**EPC STORMWATER REVIEW COMMENTS
IN ORANGE BOXES WITH BLACK TEXT**

**PCD-ENGINEERING REVIEW COMMENTS
IN BLUE BOXES WITH BLUE TEXT**

THE HILLS AT LORSON RANCH FILING NO. 1

FINAL GRADING / EROSION CONTROL PLANS

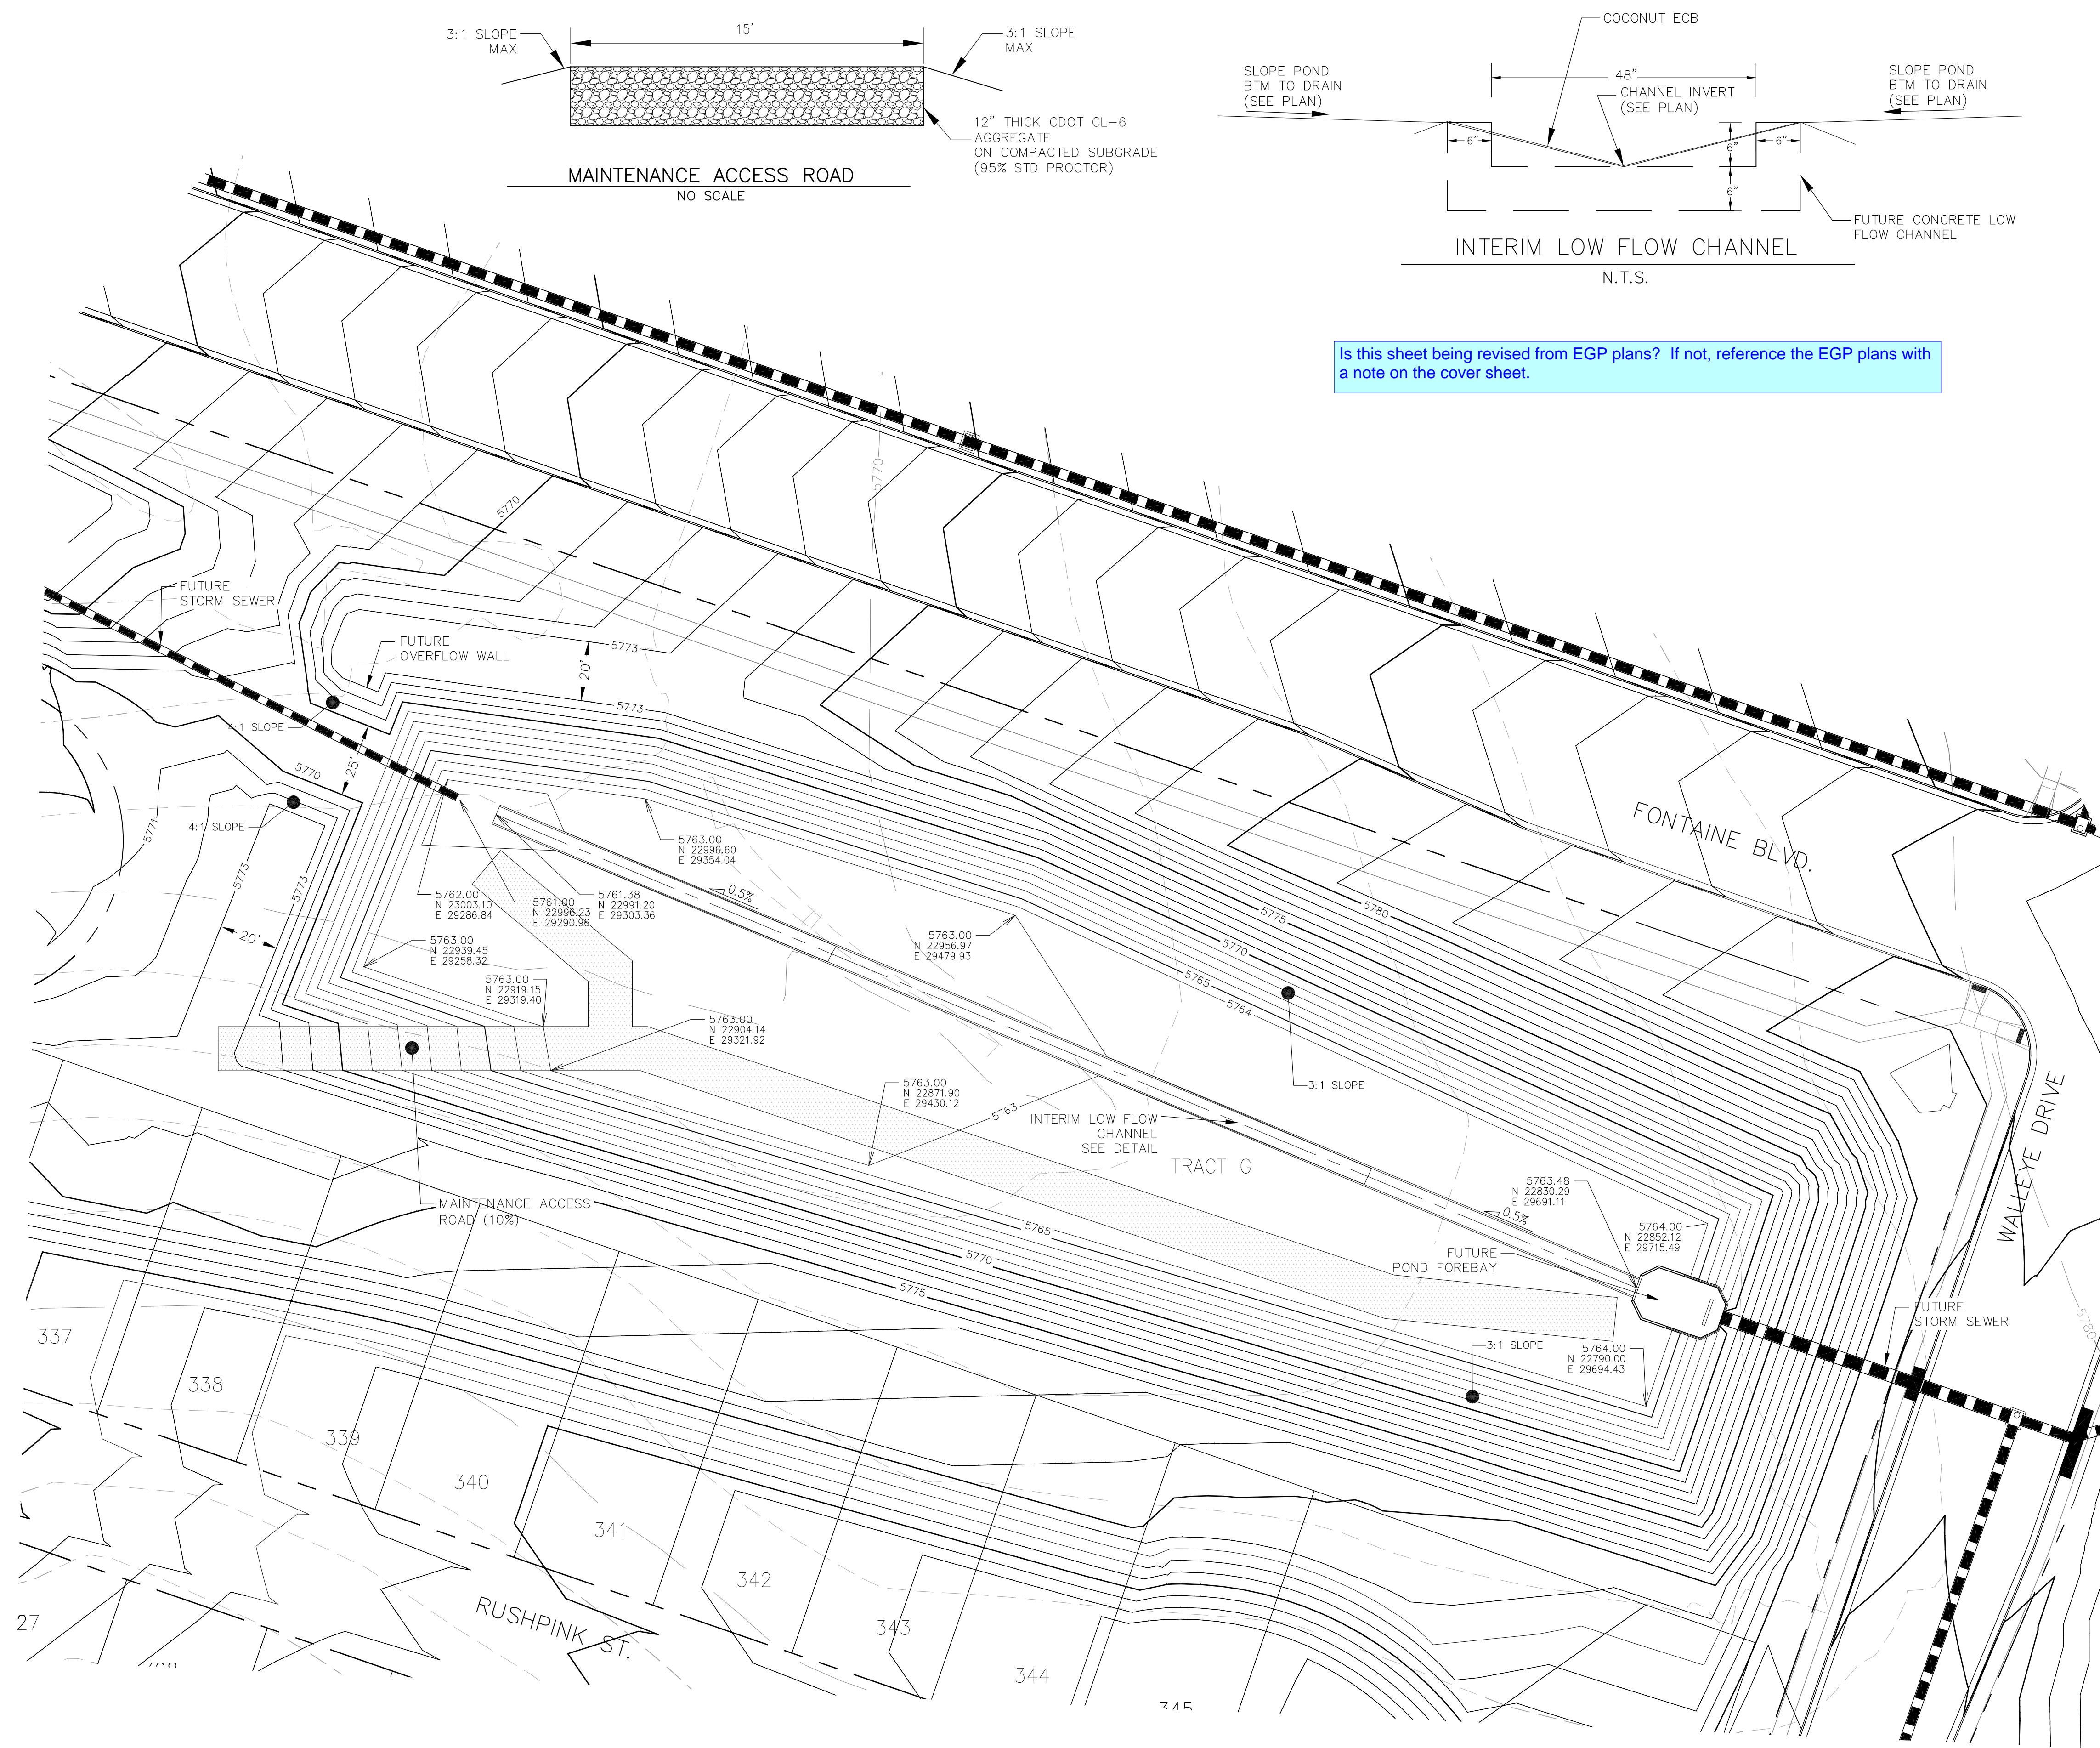
Is this sheet being revised from EGP plans? If not, reference the EGP plans with a note on the cover sheet.

DATE: JAN 18, 2021
 PROJECT NO. 100.062
 SHEET NUMBER C5.4
 TOTAL SHEETS: 16

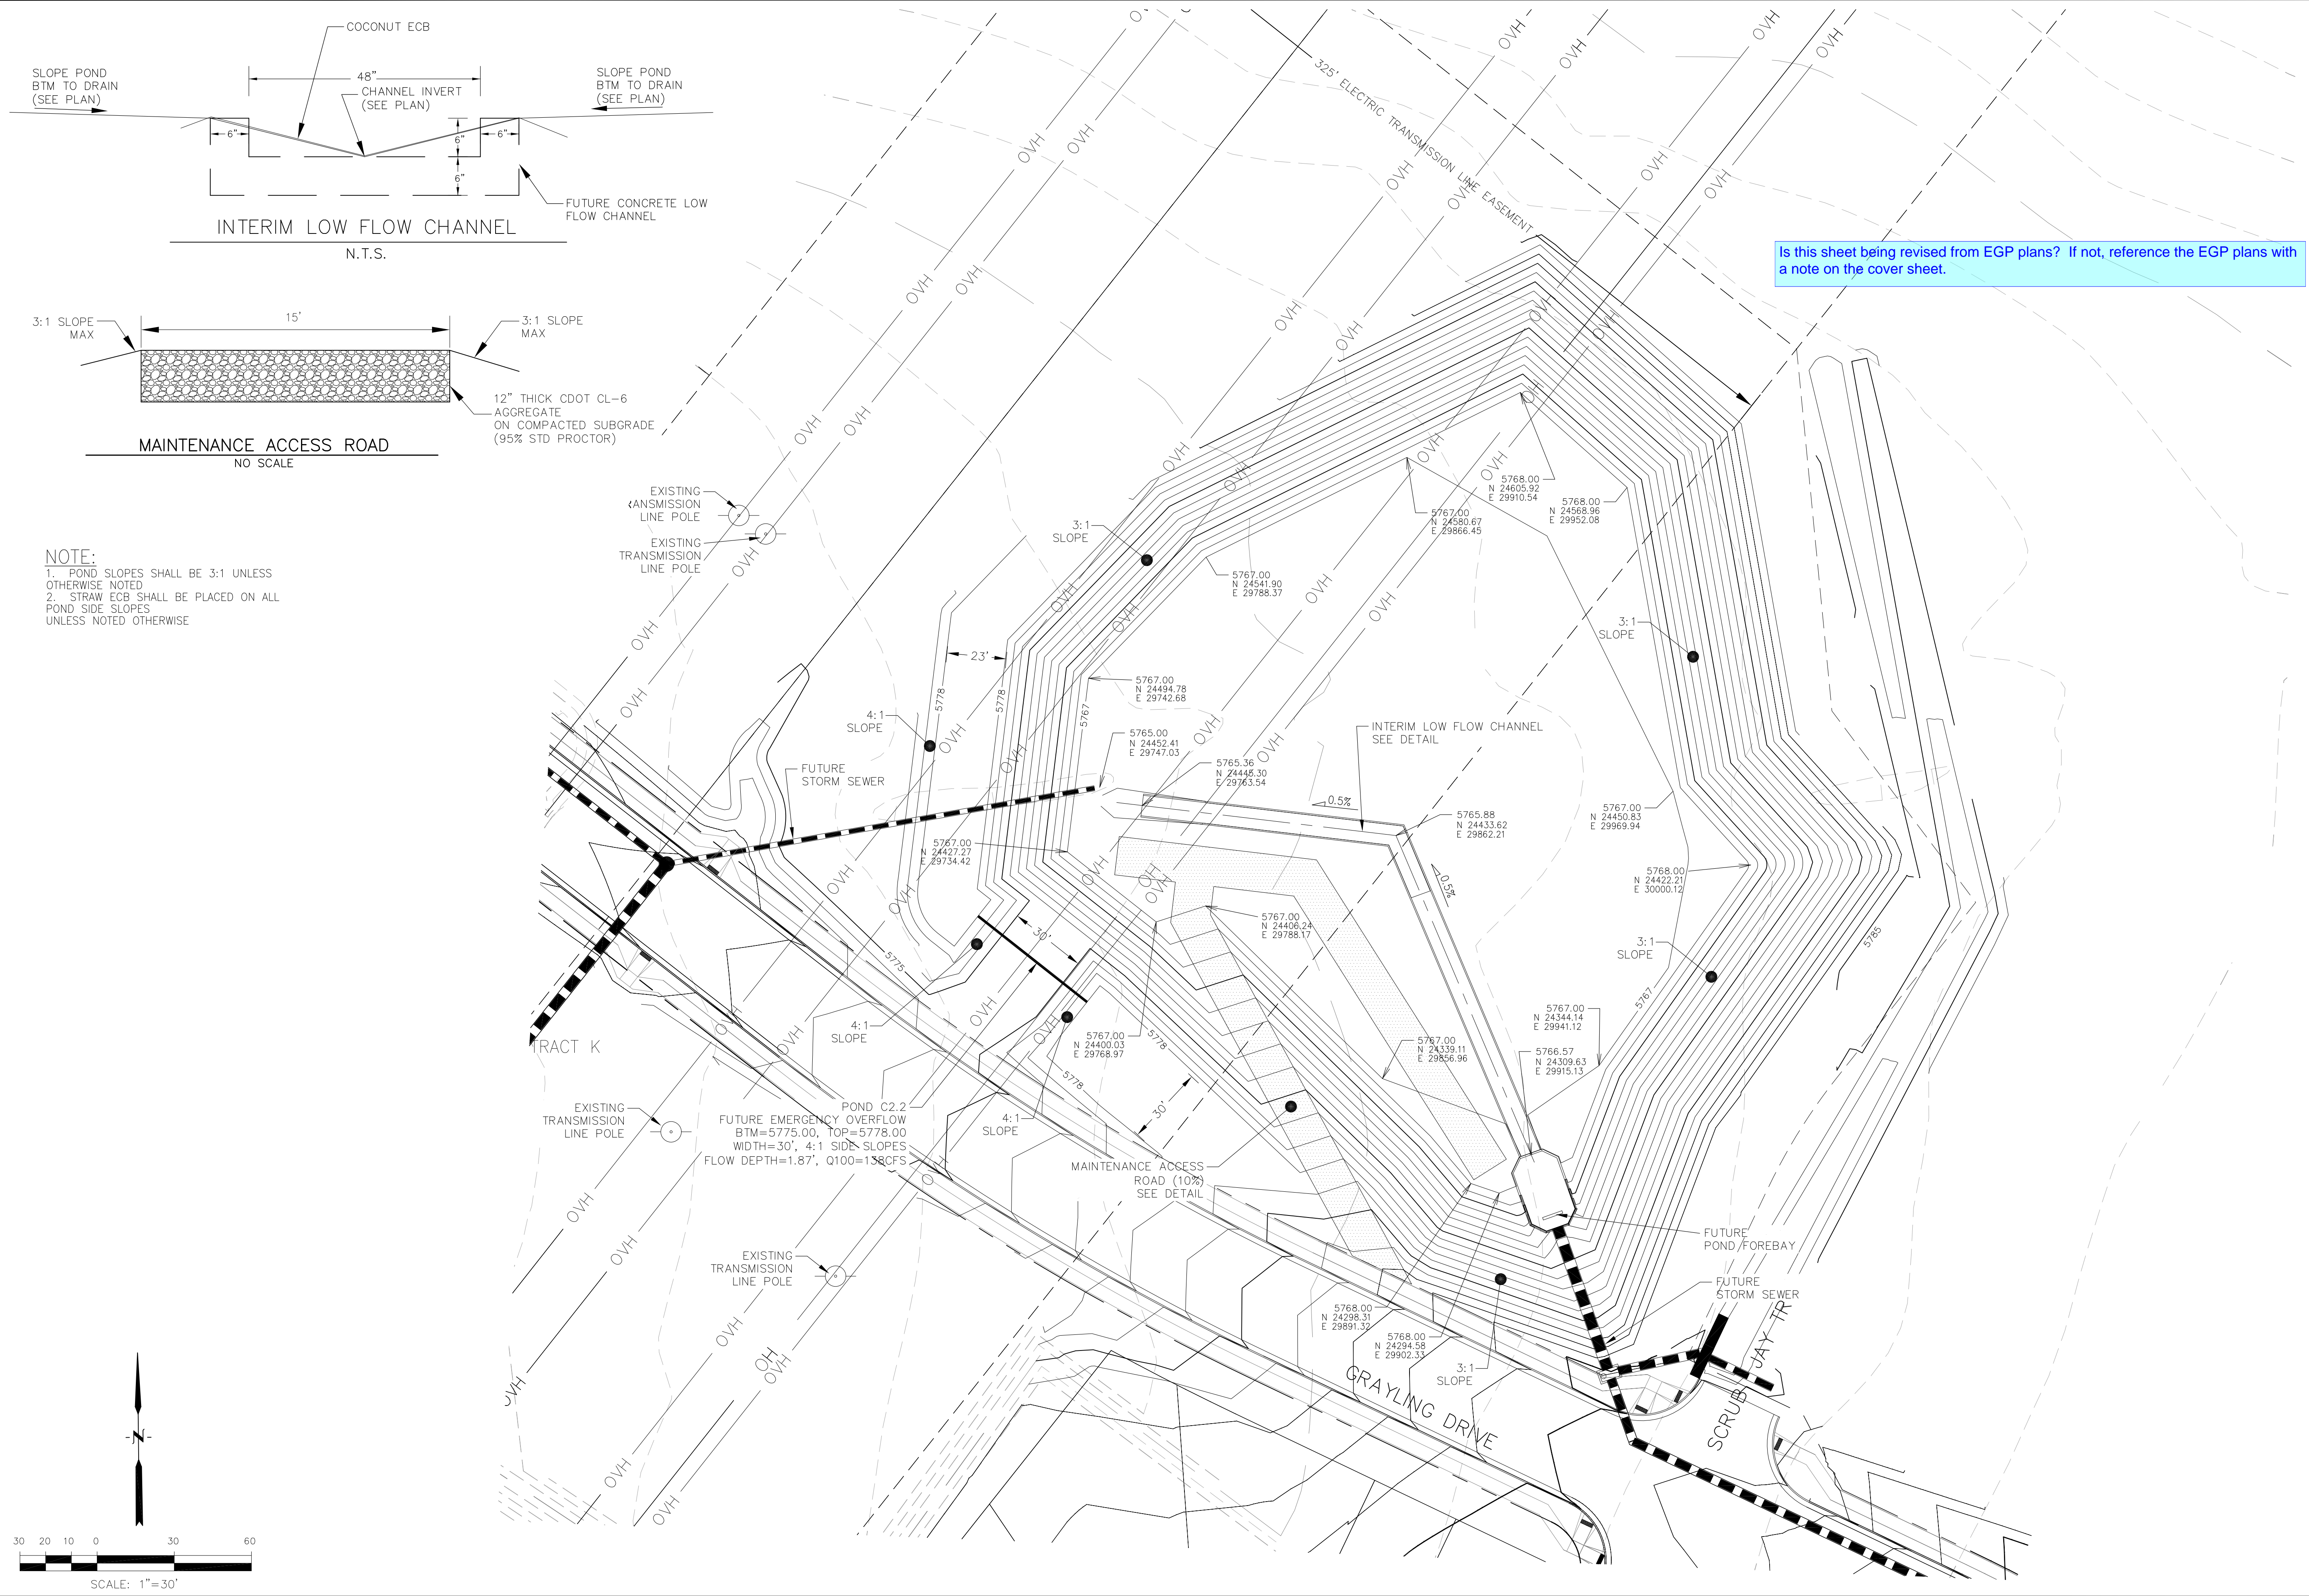
Is this sheet being revised from EGP plans? If not, reference the EGP plans with a note on the cover sheet.
